UNITED STATES PATENT AND TRADEMARK OFFICE

APPLICATION NO.	FILING DATE	FIRST NAMED INVENTOR	ATTORNEY DOCKET NO.	CONFIRMATION NO.
09/681,674	05/18/2001	Yoshifumi Natsuyama	JP920000096US1	3666

**Office Action Summary**Application No. 16

## **DETAILED ACTION**

Figure 11

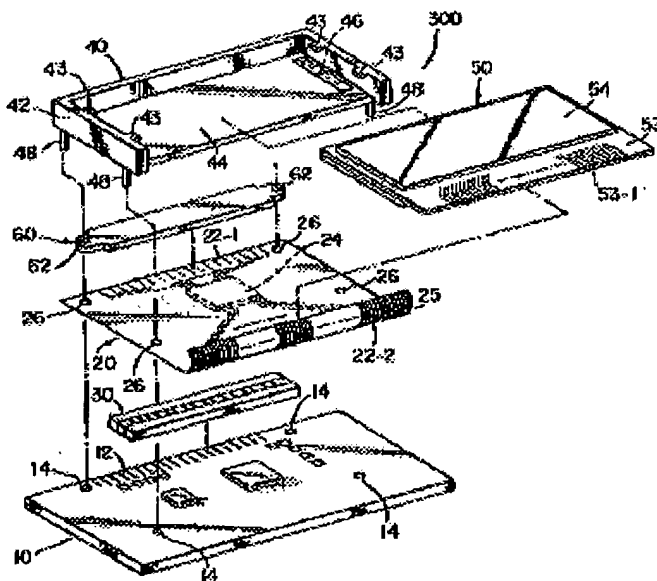
As to claim 4, Muramatsu discloses in his third embodiment, Figures 11 and 12, (col. 10 line 66 through col. 13, line 6) a liquid crystal display device, 50, comprising: a pair of glass substrates facing each other, each having electrodes for applying voltage to a liquid crystal material on a facing surface (typical); a circuit board, 10, for supplying said voltage; and a liquid crystal driver tape carrier package, 20, (col. 11, lines 7-9 and col. 7, lines 1-3) for connecting said electrodes of said glass substrates to said circuit board and mounting a liquid crystal driver chip (col. 11, lines 7-9 and col. 7, lines 4-13), wherein said liquid crystal driver tape carrier package and said circuit board anchor holes, 26 and 14, and anchor pins, 48, are inserted into said anchor holes, whereby said liquid crystal tape carrier package is fixed to said circuit board (col. 11, lines 45-48).

As to claim 5, Muramatsu discloses the liquid crystal display device according to claim 4 further comprising a light guide, 44 (Applicant's frame), for allowing said anchor pins to stand on a surface holding said pair of glass substrates, wherein said liquid crystal driver tape carrier package and said circuit board are fixed to said frame.

As to claim 6, Muramatsu discloses the liquid crystal display device according to claim 4, wherein a pair of said anchor holes, 26, is located with said liquid crystal driver chip, 24, between (diagonally per Figure 11).
